UNITED STATES PATENT AND TRADEMARK OFFICE

| APPLICATION NO. | FILING DATE | FIRST NAMED INVENTOR | ATTORNEY DOCKET NO. | CONFIRMATION NO. |
|-----------------|-------------|----------------------|---------------------|------------------|
| 10/538,010 | 06/03/2005 | Shinichi Ookubo | 040894-7251 | 6869 |

Office Action Summary

DETAILED ACTION

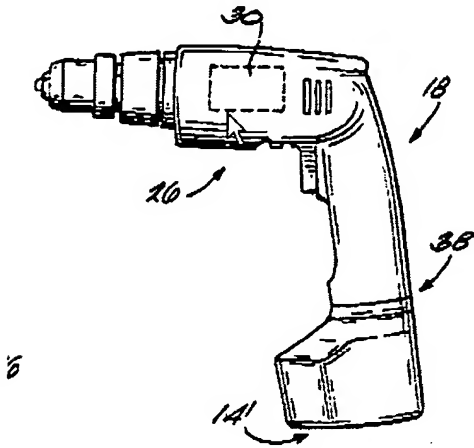
Kubale discloses in figures 1A-11B a cordless power tool 18

a power supply 14 of a motor 54 [see fig.1A],

along an opening axis 50. In this configuration, a motor terminal assembly 54 (schematically illustrated in FIGS. 3B and 4B) is

and rechargeable by an external power supply [see fig.2A; column 6, lines 12-16].

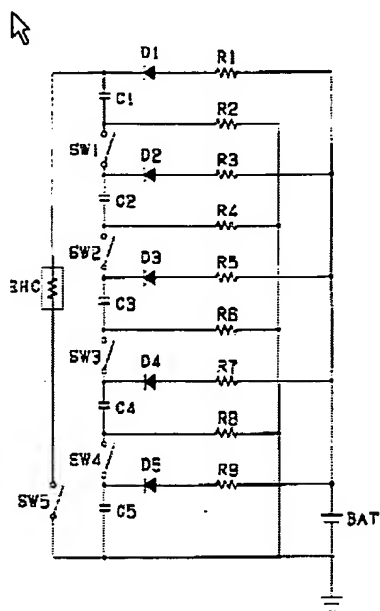
JP-09285006 discloses in the abstract and figures 1-2

a power supply comprising a plurality of capacitors C1-C5 and a battery BAT to supply large electric power while minimizing a burden and bad effect on a storage battery. Therefore, it would have been obvious to a person having ordinary skill in the art at the time the invention was made to modify Kubale's apparatus and include the power supply, as disclosed by JP-09285006, in order to supply large electric power while minimizing a burden and bad effect on a storage battery.

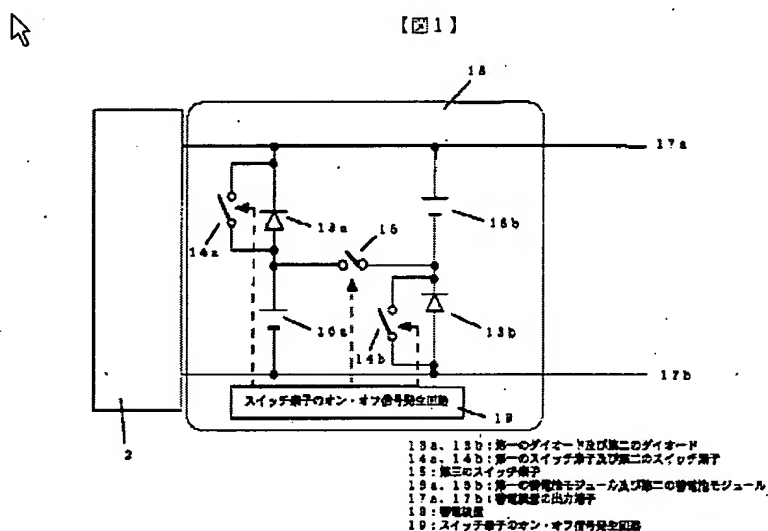
JP-2002142375 discloses

in the abstract and figures 1-9 a series parallel switching circuit that switches the plurality of electric double layer capacitors into parallel connection when a start switch is off, and switches the plurality of electric double layer capacitors into series connection when the start switch is on to obtain a power storage system wherein the charging voltages of two sets of storage battery modules are equalized using a single charger.

§ SOLUTION: The positive pole of a first storage battery module 16a and the anode of a first diode 13a and the negative pole of a second storage battery module 16b and the cathode of a second diode 13b are series connected with each other, respectively, and the diodes 13a and 13b are parallel connected with switching elements 14a and 14b, respectively. A third switching element 15 is connected between the anode of the first diode 13a and the cathode of the second diode 13b. With this constitution, the first storage battery module 16a and the second storage battery module 16b are charged independently from each other by turning on and off the two switching elements 14a and 14b. Thus passage of overcurrent due to differences in terminal voltage between the battery modules and back flow of currents to the charger due to high voltage during discharging are prevented.
